# ADDENDUM NO. 3

Rochester City School District

Dr. Walter Cooper, School #10

March 7<sup>th</sup>, 2018

**1** WINDOW DETAIL - PAN PROFILE  
3" = 1'-0"

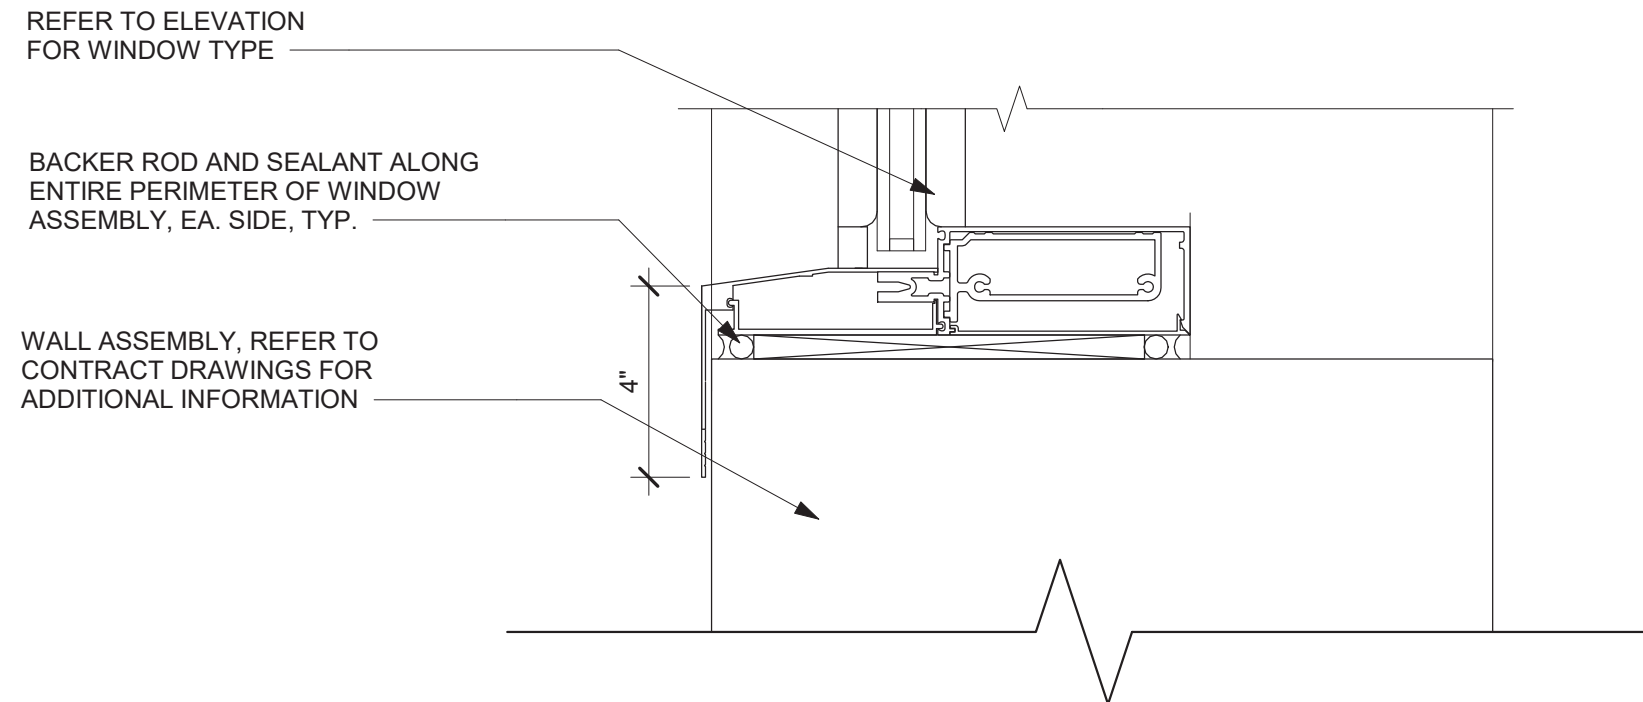
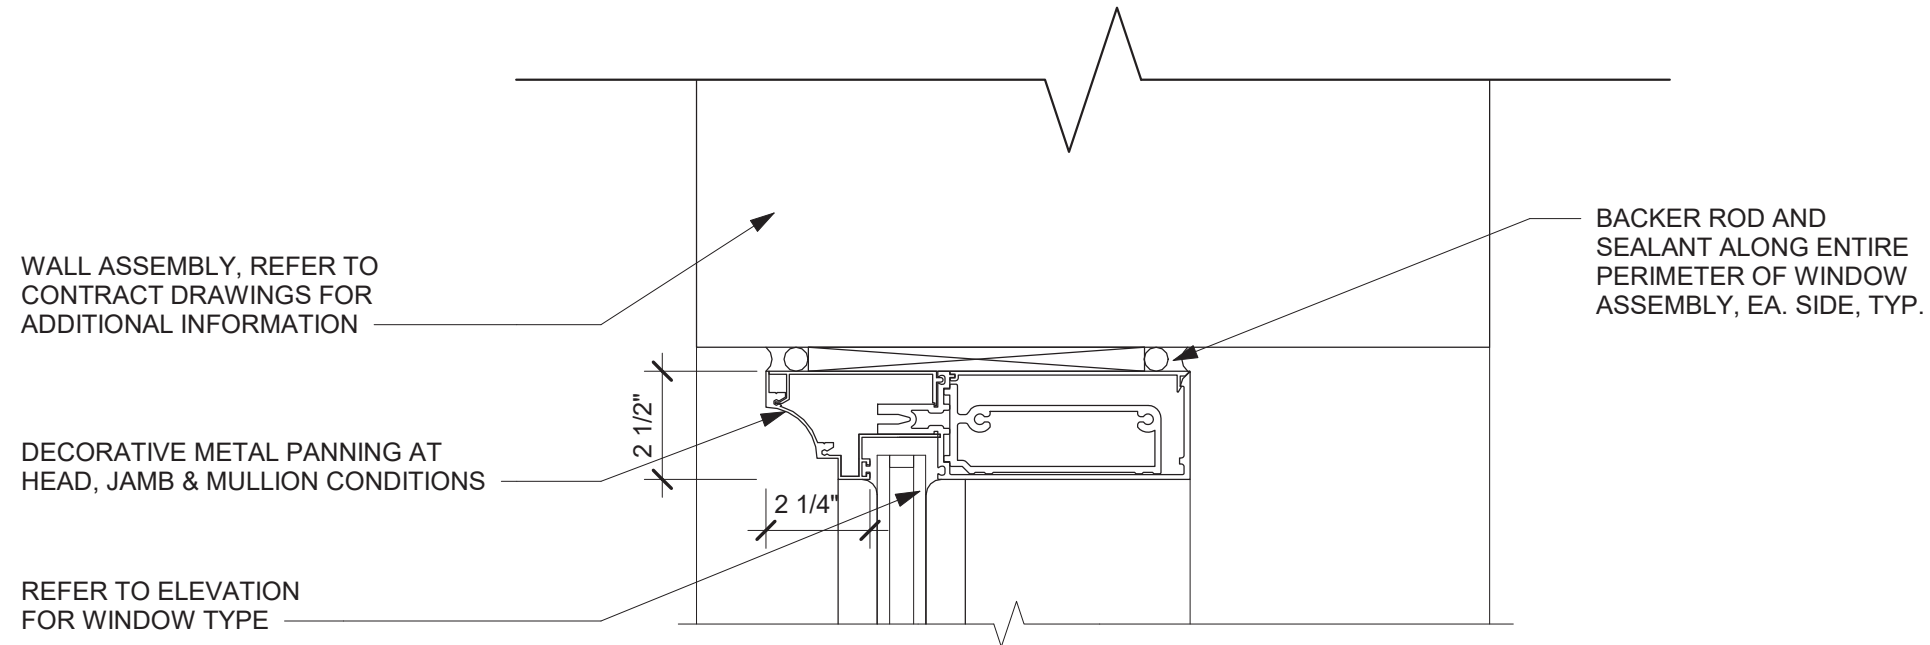
Item AD3-98 **REPLACE** detail 1/A1131 with the attached sketch “AD3-A002 – WINDOW DETAIL – PAN PROFILE.”
